MCP2510 Rev. AA Silicon Errata Sheet

The MCP2510 parts you have received conform functionally to the Device Data Sheet (DS21291C), except for the anomalies described below.

FIGURE 1: HARD SYNCHRONIZATION

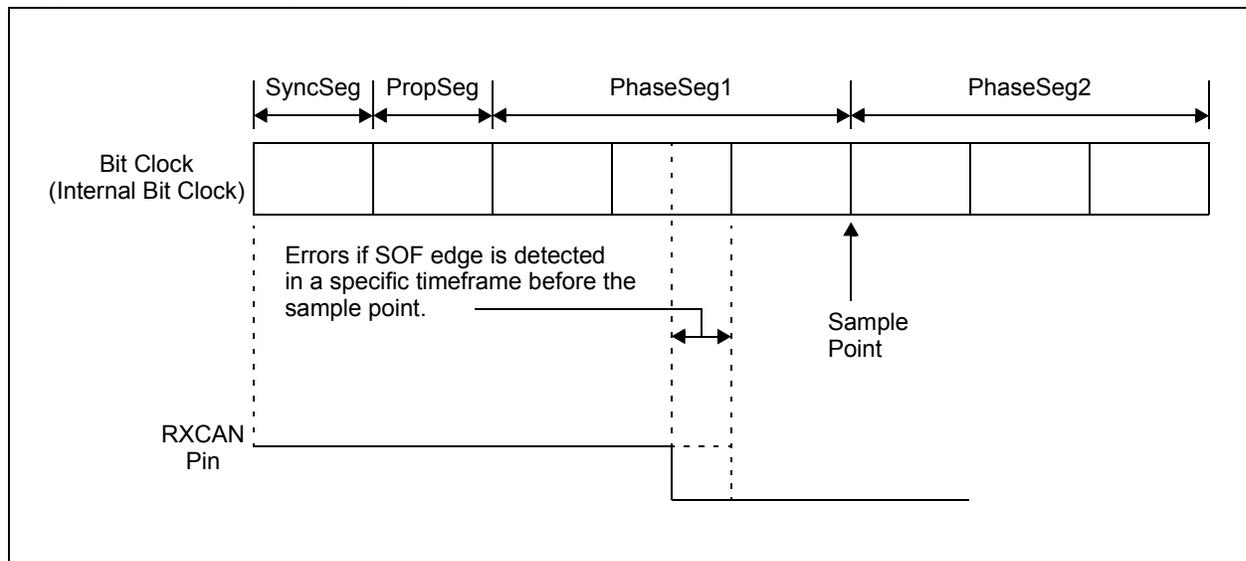
The MCP2510, as a receiver, may detect a Start Of Frame (SOF) after a long bus idle time and then generate an error on the message, causing the message to be retransmitted. There is only a small window within the bit time in which this can occur and after the initial error is sent by the MCP2510, the resent message will be received successfully and normal bus communications will resume. The following sections detail the conditions that must occur for the MCP2510 to error, including the portion of the bit time affected and the bus idle time required for the error to occur.

A receive error will occur when the MCP2510, as a receiver, detects a SOF (recessive-to-dominant) at a certain position before the sample point. As alluded to earlier, each node operates asynchronously to its own bit timing which is a function of the oscillator. During a bus idle, the nodes do not have any recessive-to-dom-

inant edges to synchronize to and soon get out of synchronization with each other. This is not usually a problem because the SOF hard synchronizes the receivers to the message.

Figure 1 illustrates the window in which the MCP2510 will mis-sample the SOF and generate an error later in the message. This Window of Susceptibility (WS) occurs 1TQ before the sample point and varies in width depending on the Baud Rate Prescaler (BRP) and the number of Time Quanta (TQ) in the bit and is discussed in detail later.

While the Window of Susceptibility exists for each bit time, the probability of the MCP2510 incorrectly sampling the SOF depends on how far the MCP2510, as a receiver, has become out of synchronization with the transmitting node. Recall in Figure 1 that for the MCP2510 to incorrectly sample the SOF, the recessive to dominant edge of the SOF must occur 1TQ before the sample point within a window depending on the BRP setting and number of TQs.

It is possible to virtually eliminate the potential for false errors, even in very light bus loads with long bus idle times, simply by using crystal oscillators with low ppm tolerances and manipulating the bit timing.

FIGURE 2: AFFECTED BIT TIME

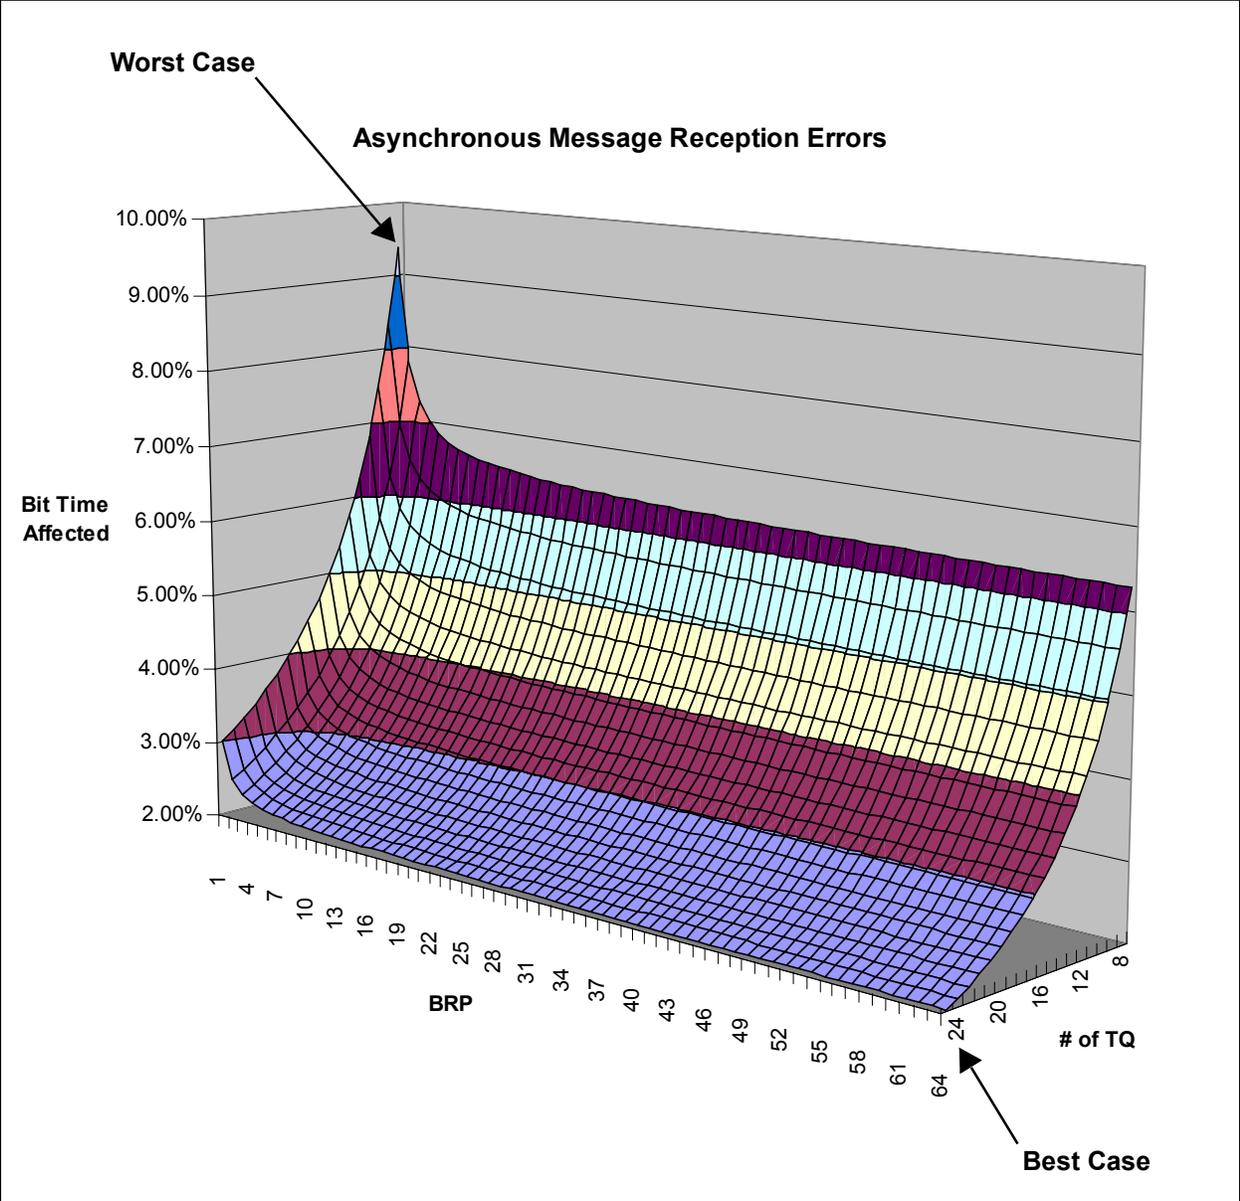
As Figure 1 illustrates, there is a small timeframe within a bit time in which a recessive-to-dominant edge will cause the SOF to be incorrectly sampled. This window of Susceptibility as a percentage of the bit time is a function of the Baud Rate Prescaler (BRP) and number of Time Quanta (TQn) and is defined as:

$$WS = \left[\frac{(BRP + 0.5)}{2(TQn)(BRP)} \right]$$

Figure 2 graphs the WS (Bit Time Affected) for all of the BRP and number of TQ settings. As the graph shows, the worst case WS occurs when the MCP2510 is configured to TQ = 8 and BRP = 1. In this case, the percentage of the bit time affected is about 9.3%. This means that, providing sufficient oscillator drift has occurred during bus idle, there is a 9.3% probability that the MCP2510 will incorrectly sample the SOF and generate an error frame. (See item 2 below).

Using a 100 ppm crystal puts the consecutive recessive bit requirement to activate the probability at approaching 10,000 bit times (20 ms).

1. #TQ = 8, BRP = 2.
This puts the probability approaching **8%**
2. #TQ = 16, BRP = 1.
This puts the probability around **3.5%**

FIGURE 3: CONSECUTIVE RECESSIVE BITS REQUIRED TO ENABLE PROBABILITY

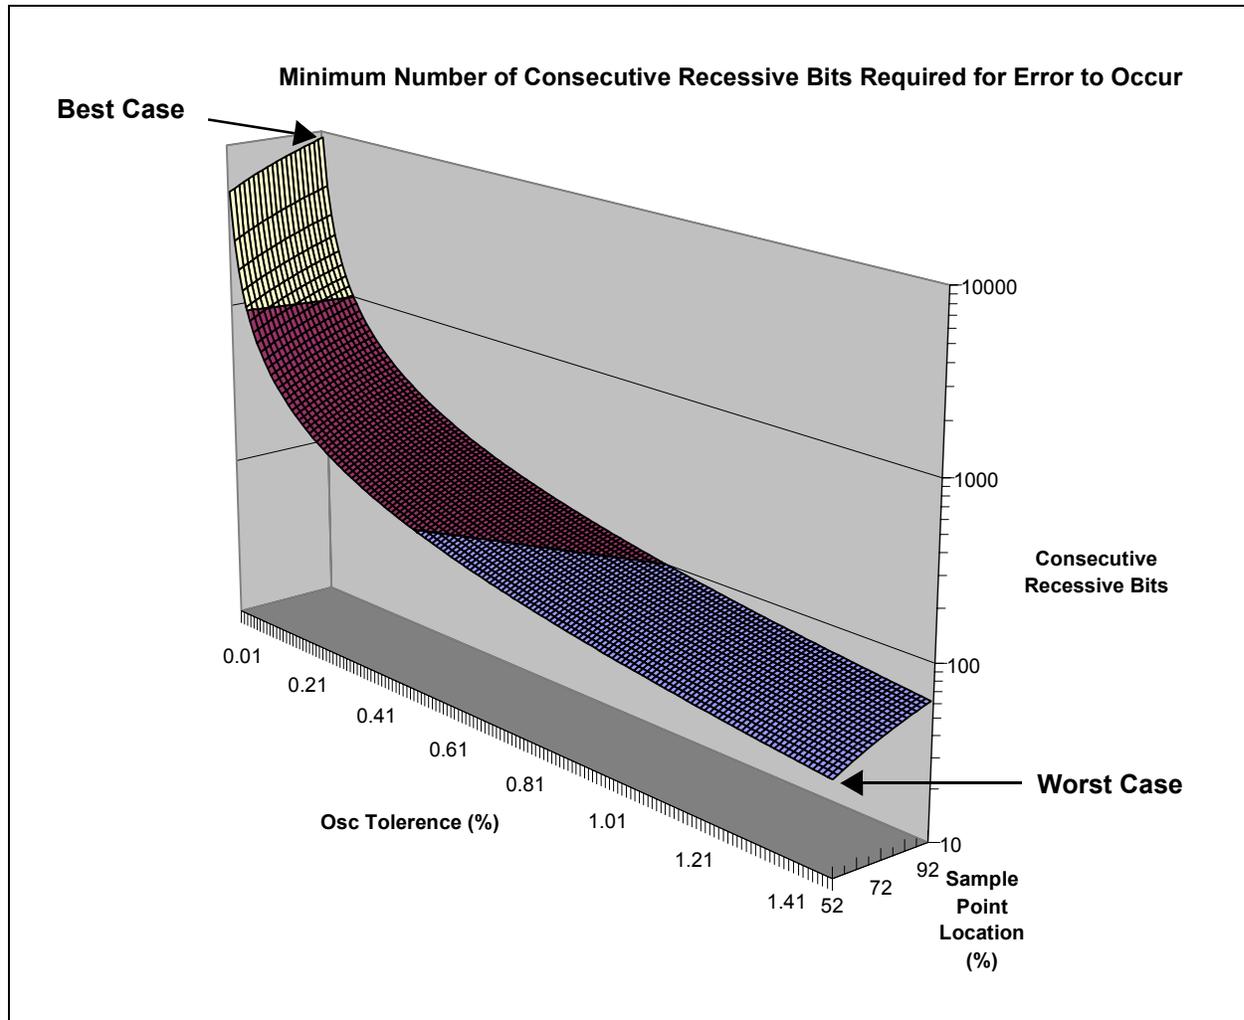
Two factors must be known to calculate how long it will take for the nodes to get far enough out of synchronization to enable the probability of a node incorrectly sampling the SOF. The two factors are the oscillator tolerances and the sample point position within the bit time. Figure 3 charts the number of consecutive recessive bits required before the probability of mis-sampling is activated. The chart uses oscillator tolerances from 0.01% (100 ppm) for crystal oscillators to 1.50% (15000 ppm) for ceramic resonators.
